## **86-100 MOUNT STREET, NORTH SYDNEY (MP08\_0241-MOD-10)**

We write on behalf of Dexu to provide a response to your letter of 4 February 2020 requesting additional information in relation to the proposed modification MP08\_0241-MOD 10. It is understood that the Department of Planning Industry and Environment (DPIE) has requested a response by Friday 14 February 2020.

**Figure 2 – Usable area of approved signage zone, showing roof plant and equipment**

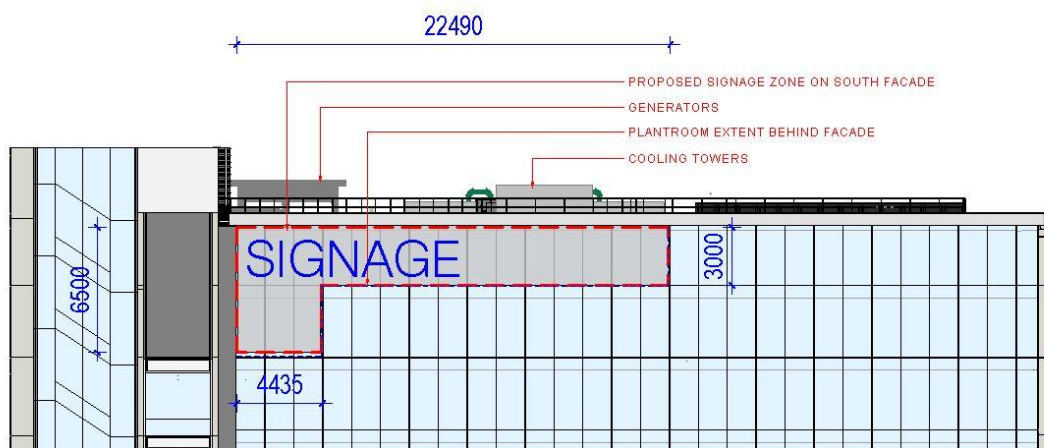
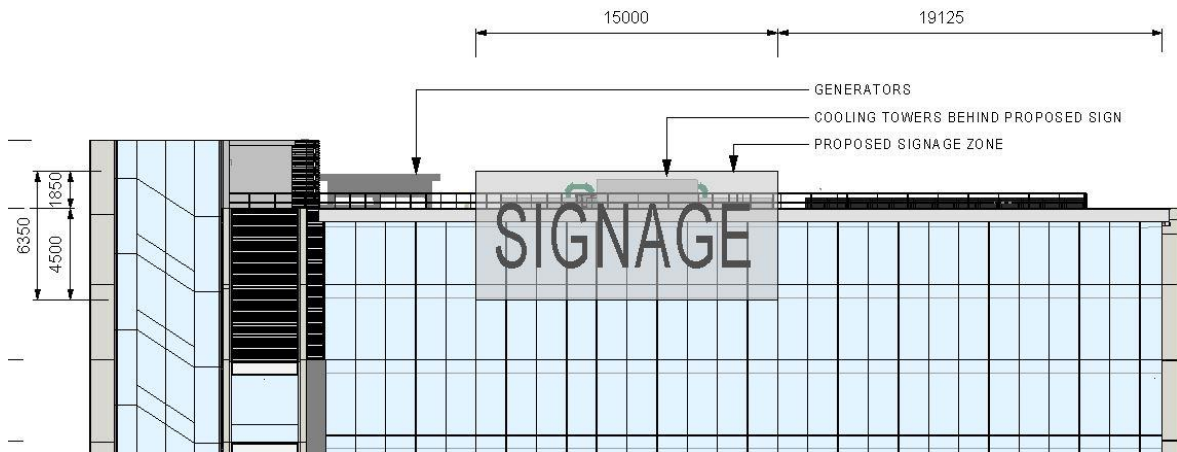
The DPIE have advised that it considers the proposed signage zone should not protrude above the parapet height, so that it does not visually dominate the skyline and is well integrated into the design of the building. We are writing to provide additional information with background on the proposed modification to the southern signage zone and to address the concerns raised in relation to visual impact, whilst maintaining a signage zone that could provide a sign that would be legible.

Figure 2 below shows what is an achievable area on the approved signage zone. The red dashed area is the area of the approved signage zone that does not cover the windows of the tenanted space of the top levels of the building, in accordance with Clause 9.4 (P8) of Section 9 of the North Sydney DCP 2013. It is evident the available space would not provide a suitable area for an aspect ratio required for a legible sign 190 metres in the air.
